DEMOLITION OF EXISTING STRUCTURES AND CONSTRUCTION OF FUEL FILLING DEPOT INCLUDING ANCILLARY OFFICES, FACILITIES AND WIDENING OF ACCESS ROAD, AT ĦAS-SAPTAN, OFF VJAL L-AVJAZZJONI, ĦAS-SAPTAN, GĦAXAQ

**ADDENDUM TO
ENVIRONMENTAL PLANNING STATEMENT**

Comments on the 1st draft of the Environmental Planning Statement (EPS)

PA03607/16 [EA 00003/16] - Demolition of existing structures and construction of fuel filling depot including ancillary offices, facilities and widening of access road. Site at Has-Saptan, off Vjal I-Avjazzoni, Has-Saptan, Għaxaq, Malta

SECTIONS THROUGH DAY TANKS

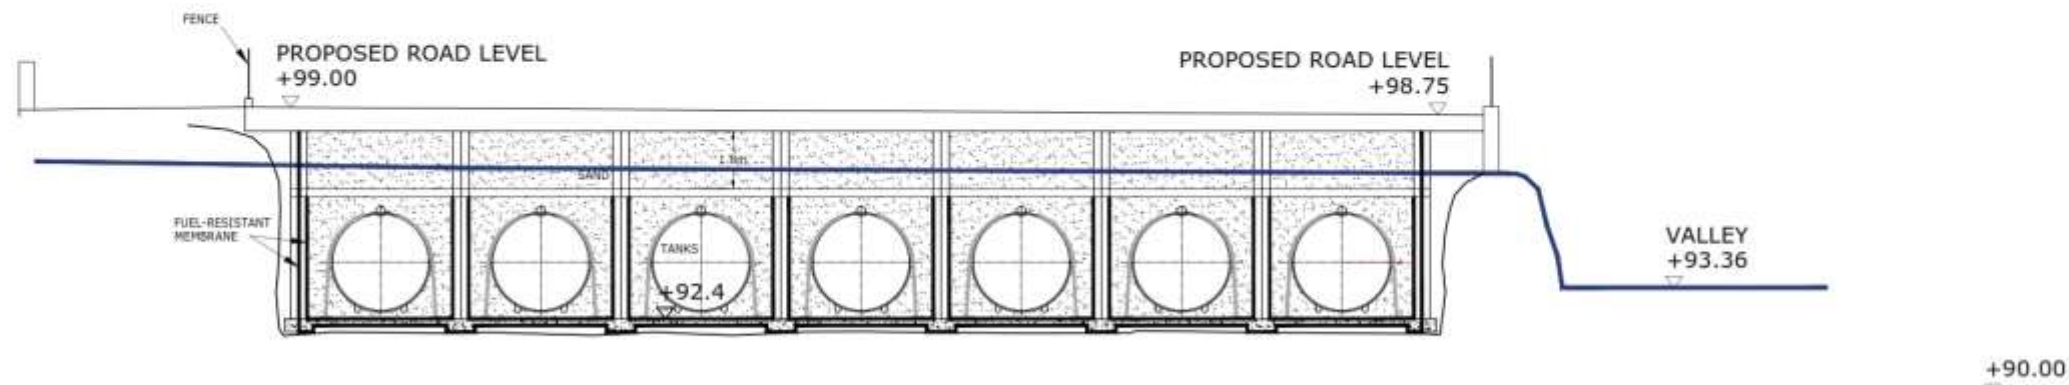
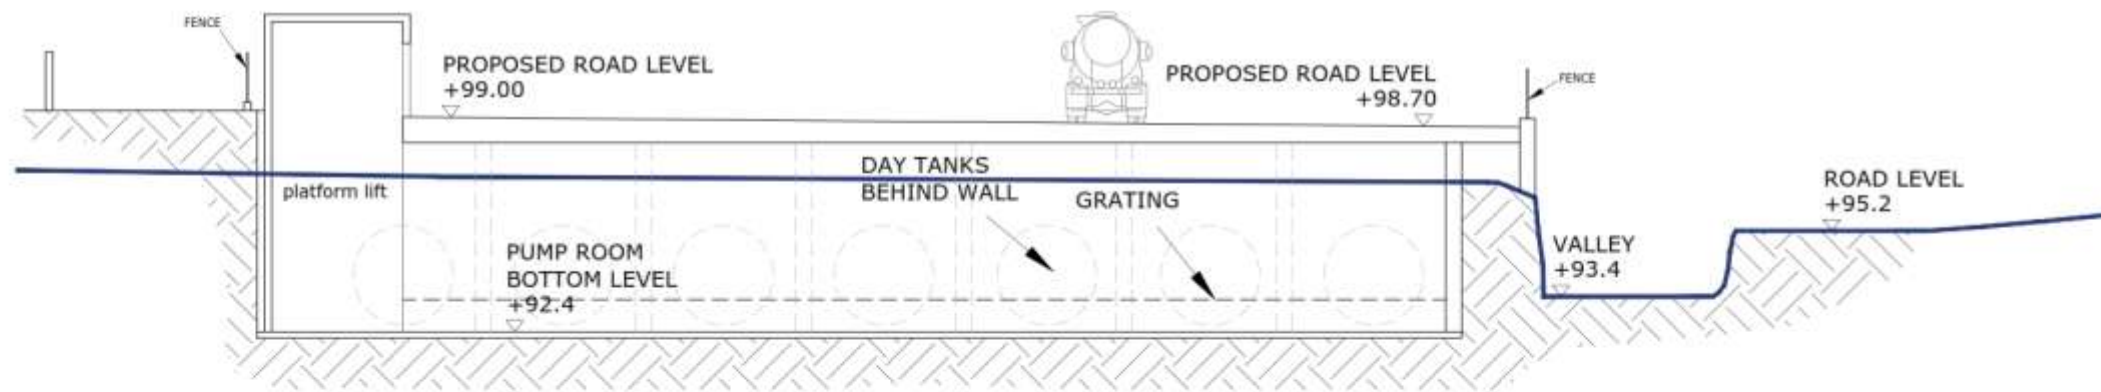
(REWS) showing how these are/shall be constructed and operated in accordance to the relevant requirements is required.	petrol station in Malta.				
4	/	Changes in plans	<p>Drawings 008B and 009B (page 39 and 41) are to be updated to indicate how each day-tank will be individually banded in line with the engineer's report in the REWS clearance and Drawing 6A of the Risk Assessment Report.</p> <p>Updated plans showing the location of the calibrating tank referred to in item no. 3.26 of the Master EPS document. Such a tank needs to be provided with impermeable bunding of a capacity equal to or greater 110% the total capacity of such tank.</p>	<p>See Annex I for updated plans.</p> <p>The calibrating tank is a tank on wheels which is taken to the road-tanker filling area when calibrating the meters. The tank is immediately emptied into the day tanks before being returned to its store. Additionally, it is noted that the entire Scheme site will be linked to oil-water interceptors.</p> <p>See updated plans in Annex I.</p>	<p>Noted</p> <p>Noted.</p> <p>Noted</p>	No further comments.	/	/

Note: Each fuel tank will be installed within a fuel tight bund and the inside surface of each bund will be lined with a fuel resistant membrane.
